# NORTHWORKS Hunt Residence ARC -24-0106 ZON-24-0063 260 Colonial Ln, Palm Beach, FL 33480

## **NEW PROPOSED ROOF PLAN**

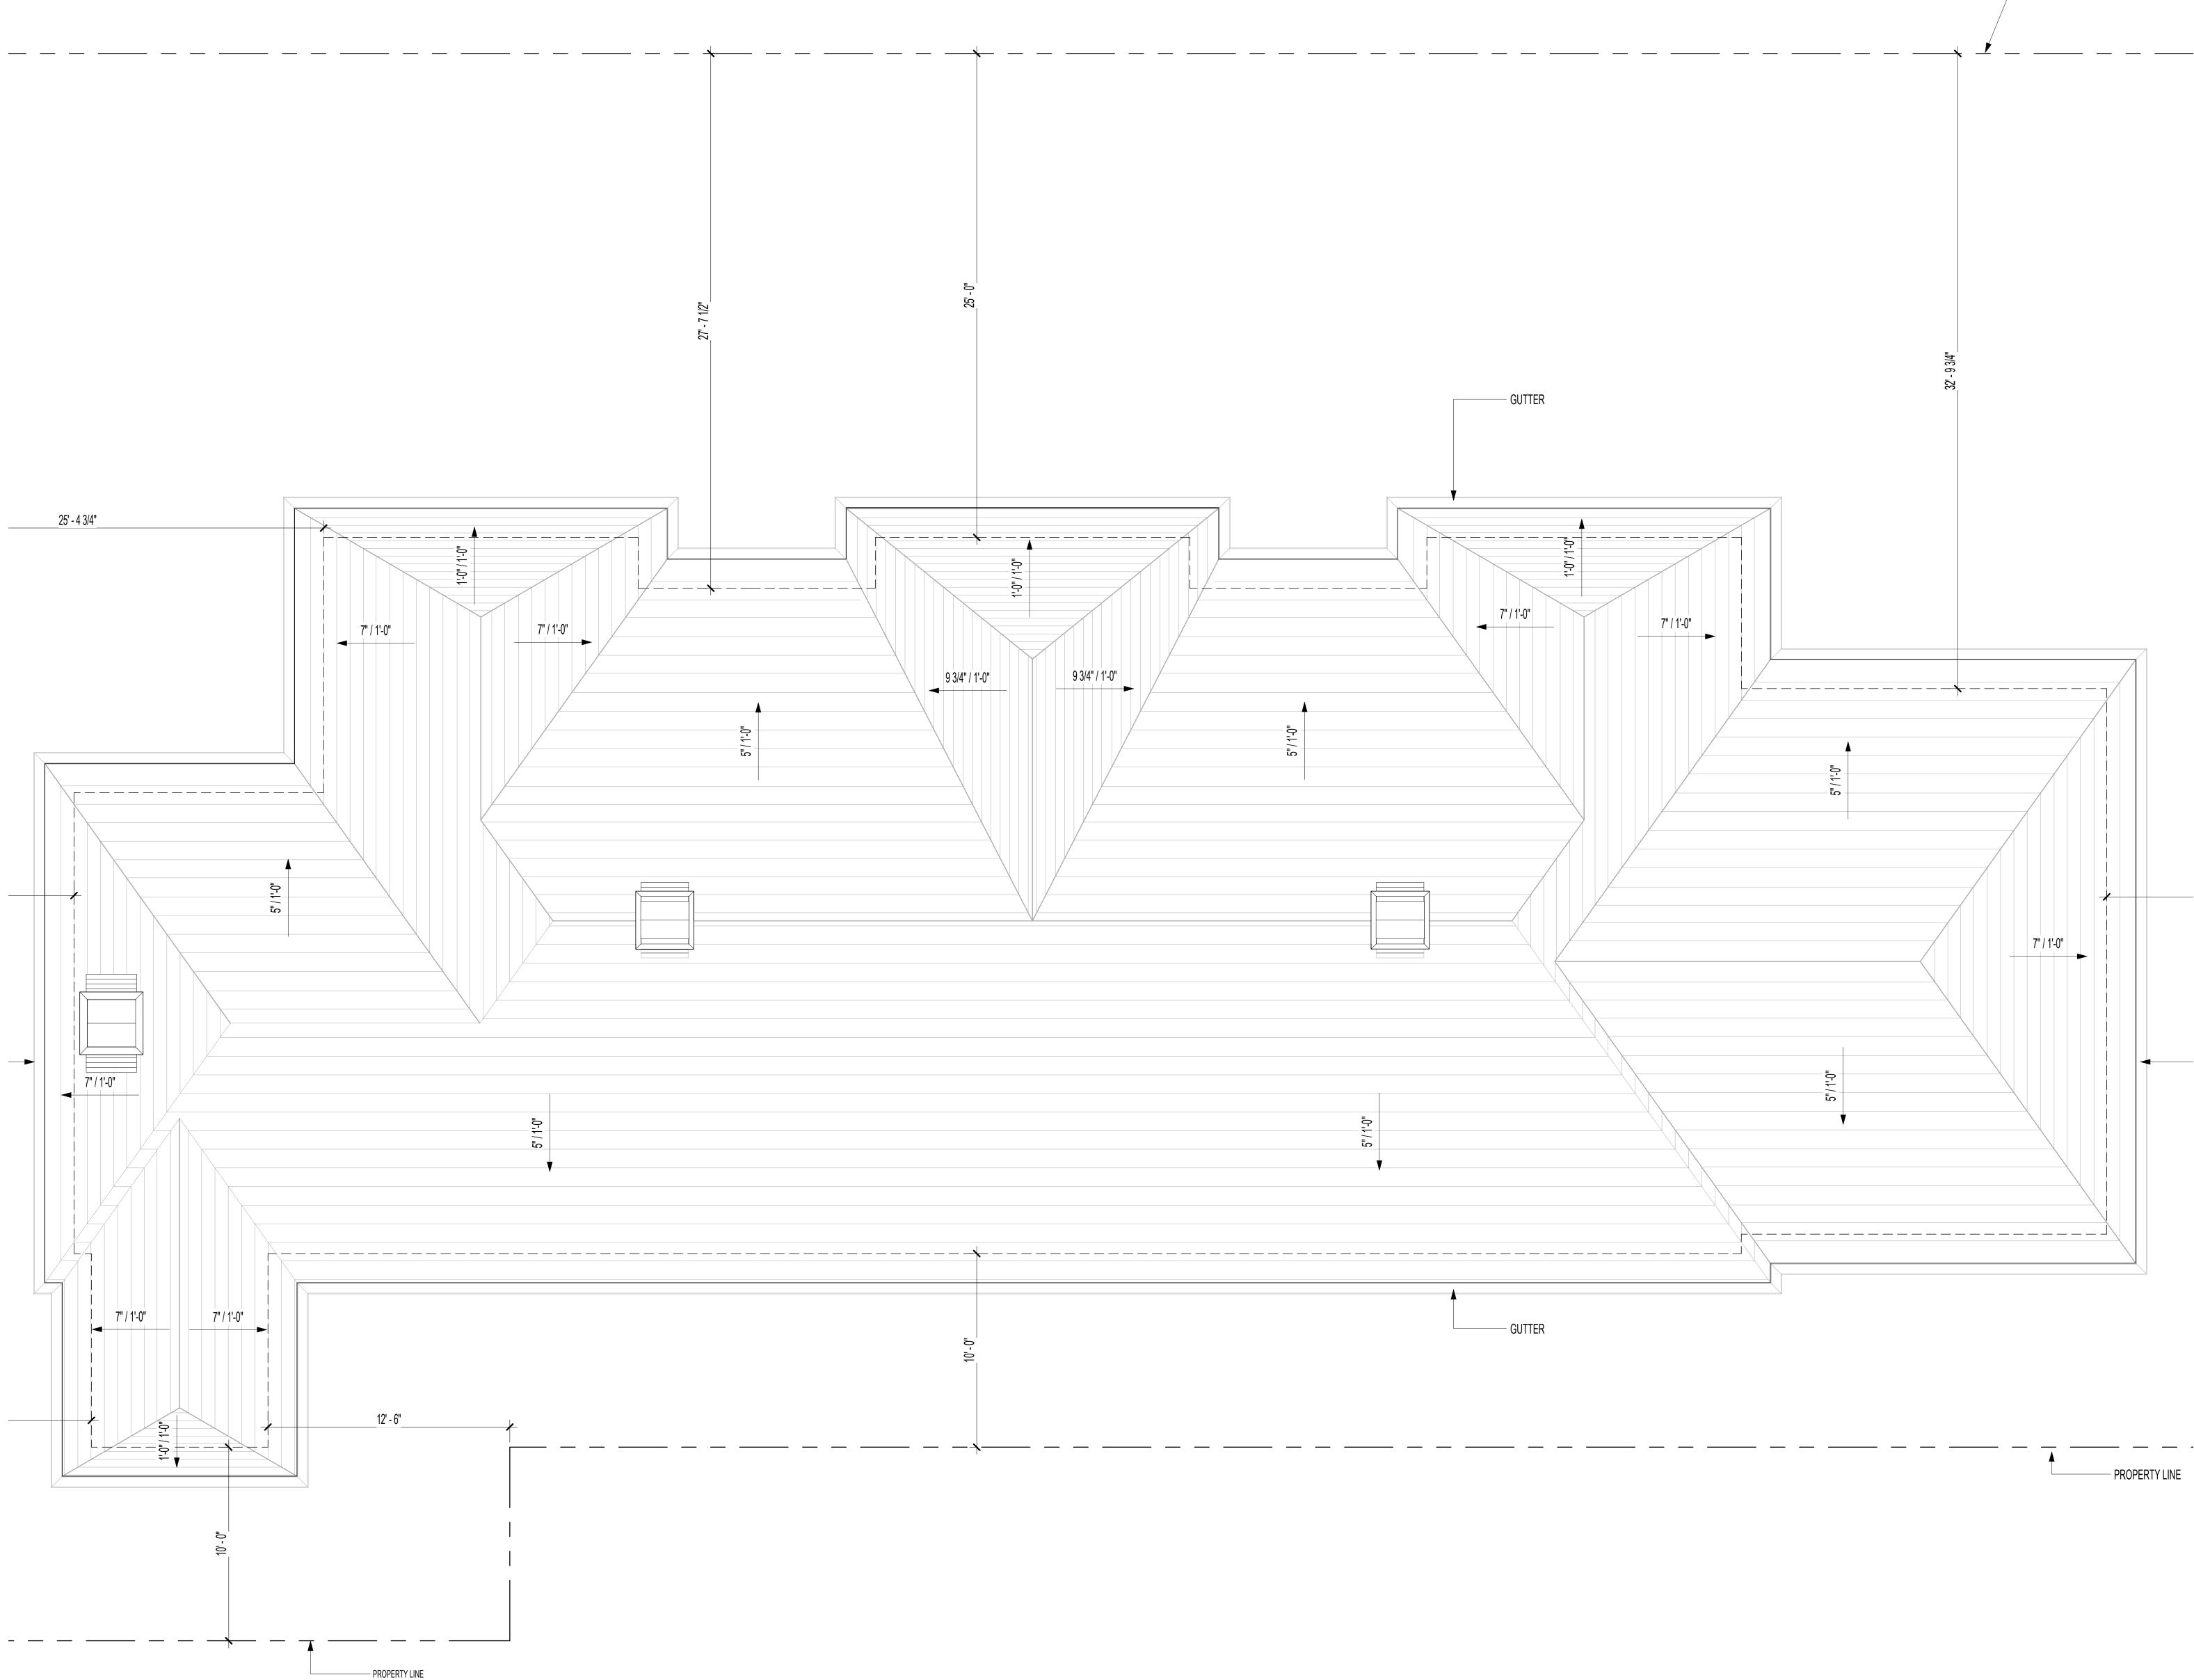
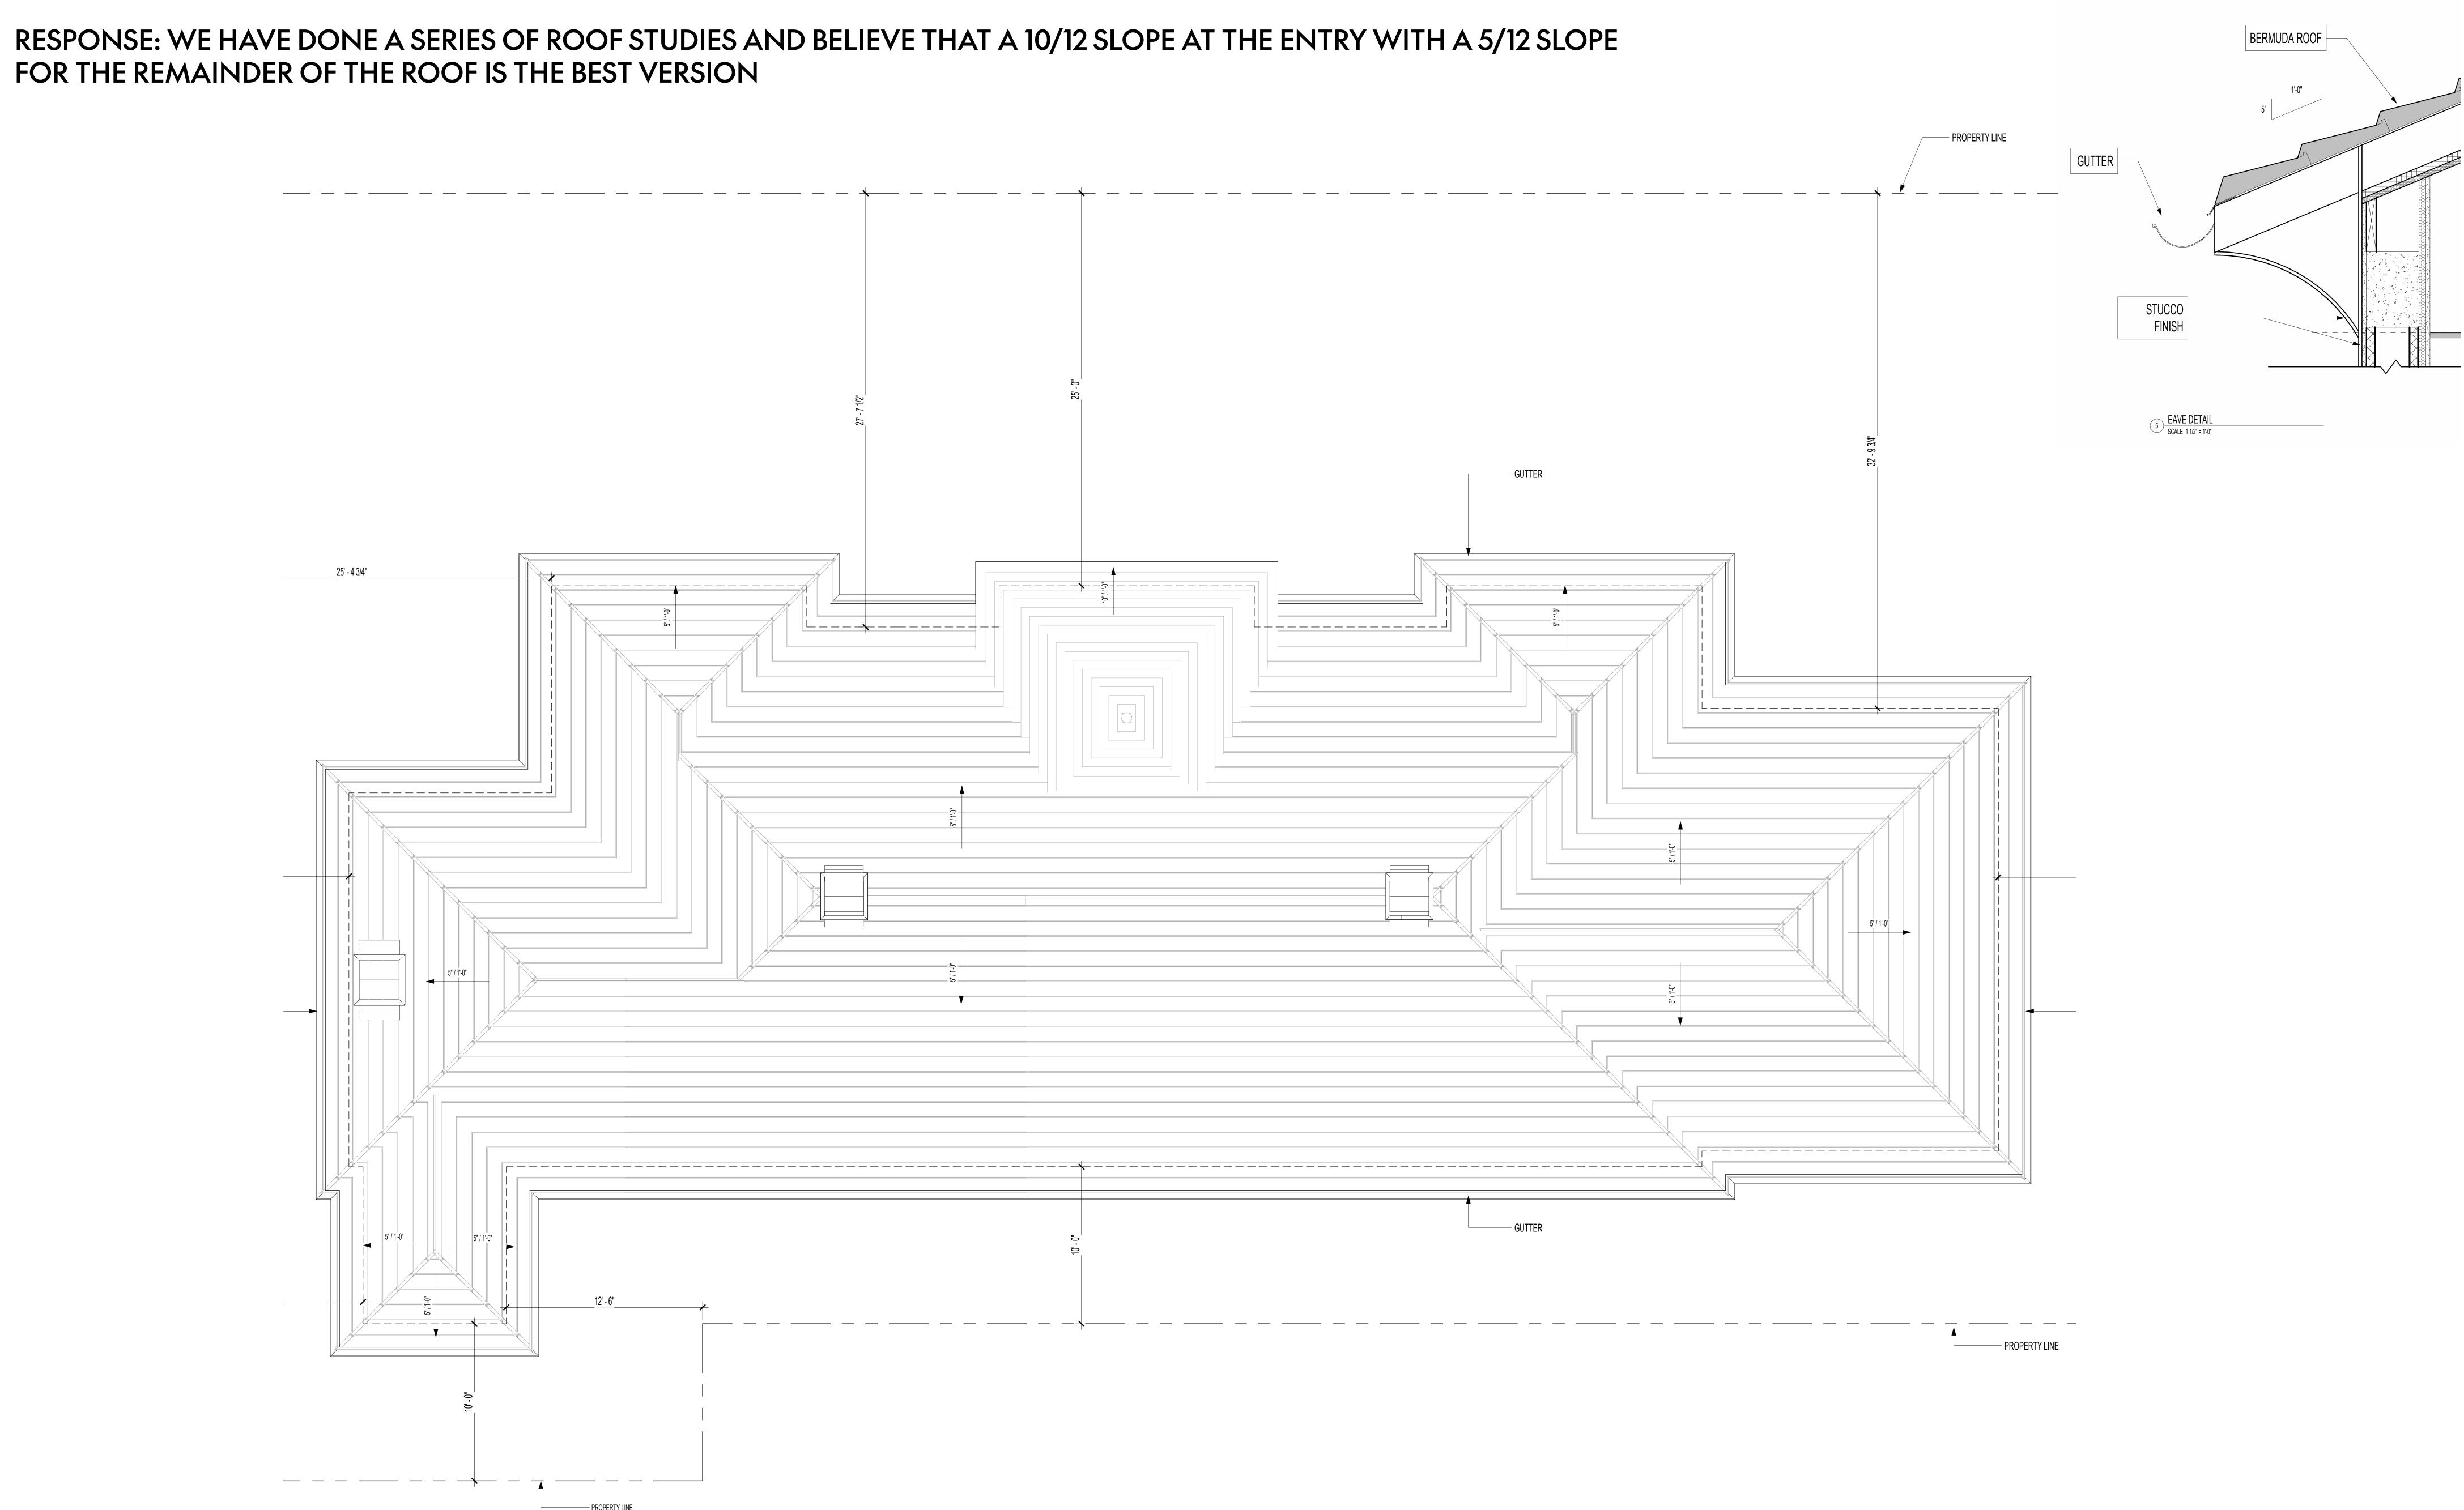
# COMMENT 1 - REGULARIZE ROOF SLOPES

## RESPONSE: WE HAVE DONE A SERIES OF ROOF STUDIES AND BELIEVE THAT A 10/12 SLOPE AT THE ENTRY WITH A 5/12 SLOPE FOR THE REMAINDER OF THE ROOF IS THE BEST VERSION

## NEW PROPOSED DRIVEWAY

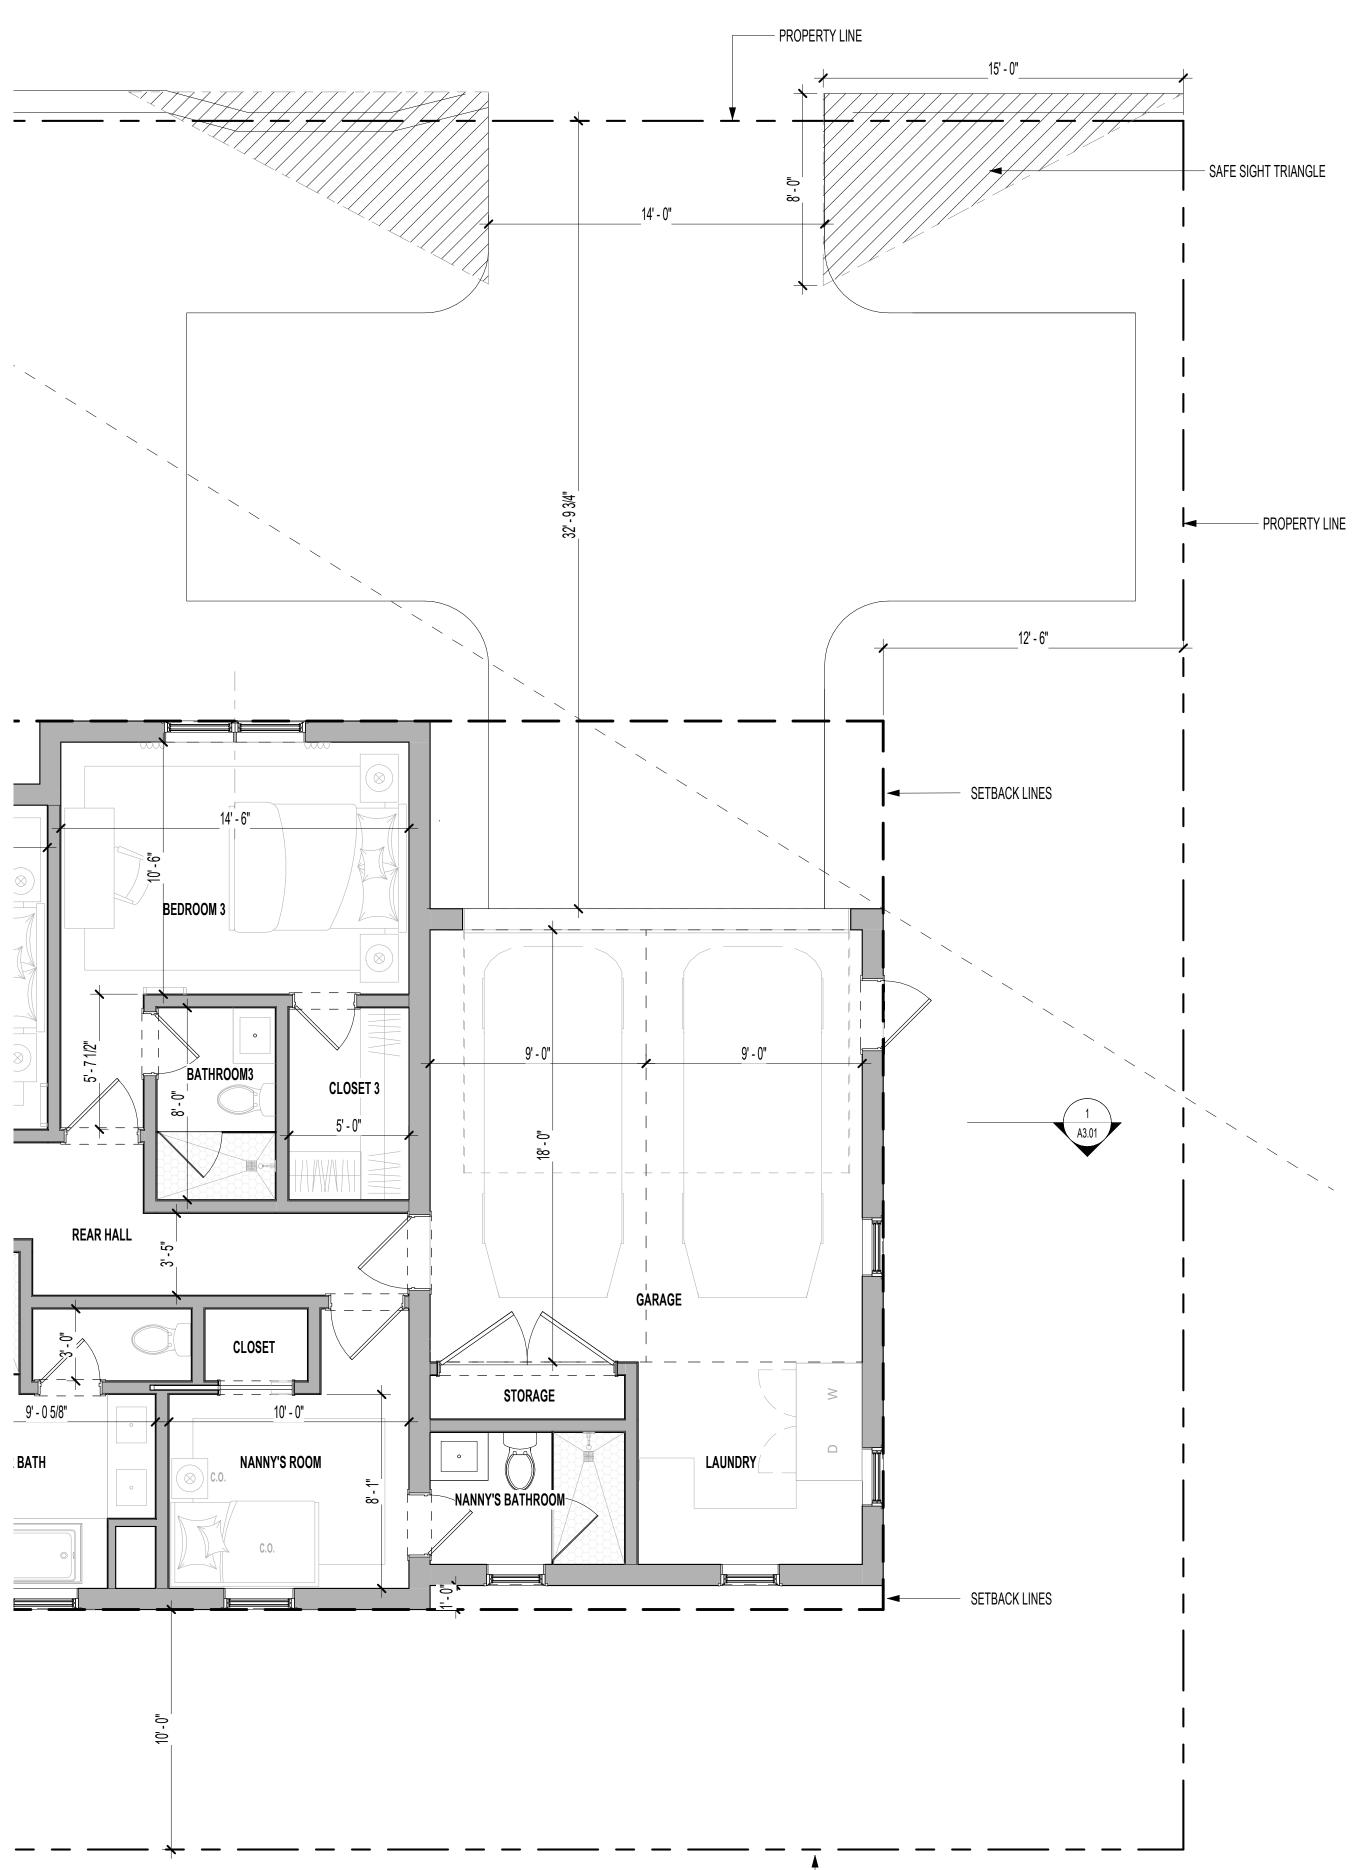
# **COMMENT 4- REDUCE DRIVEWAY SIZE**

# **RESPONSE: THE DRIVEWAY HAS BEEN REDUCED BY 1 FOOT ON EVERY SIDE**
